## **DEPARTMENT OF TRANSPORTATION**

### **Federal Aviation Administration**

**[Docket No. FAA-2022-1647; Project Identifier AD-2022-01379-T; Amendment 39-22438; AD 2023-10-02]**

### **Airworthiness Directives; Transport and Commuter Category Airplanes**

Figure 1 to paragraph (g)(1)(i)— *Fundamental Effective Isotropic PSD at Outside Interface of Airplane Antenna*

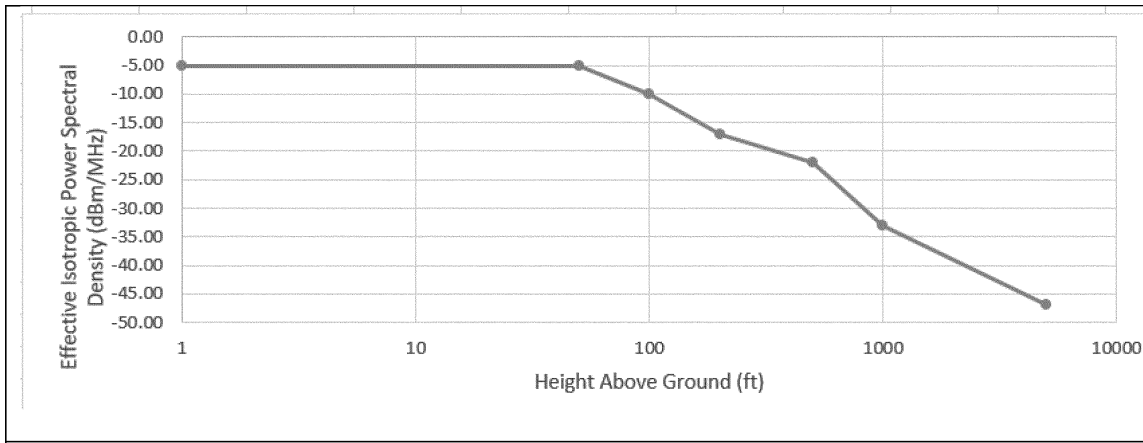
### **4. Request To Clarify Figure 1**

*Comment summary:* Textron Aviation requested the FAA clarify at what reference point the PSD requirements apply. The commenter stated it assumed that they apply at the radio altimeter receive antenna input, such that antenna characteristics, coax loss, and filter characteristics would be included in the determination.

*FAA response:* The FAA agrees and has changed the title of figure 1 to paragraph (g)(1)(i) of this AD to reflect that the PSD requirements apply at the antenna input to the radio altimeter, and that the figure applies to the outward facing side of the antenna.
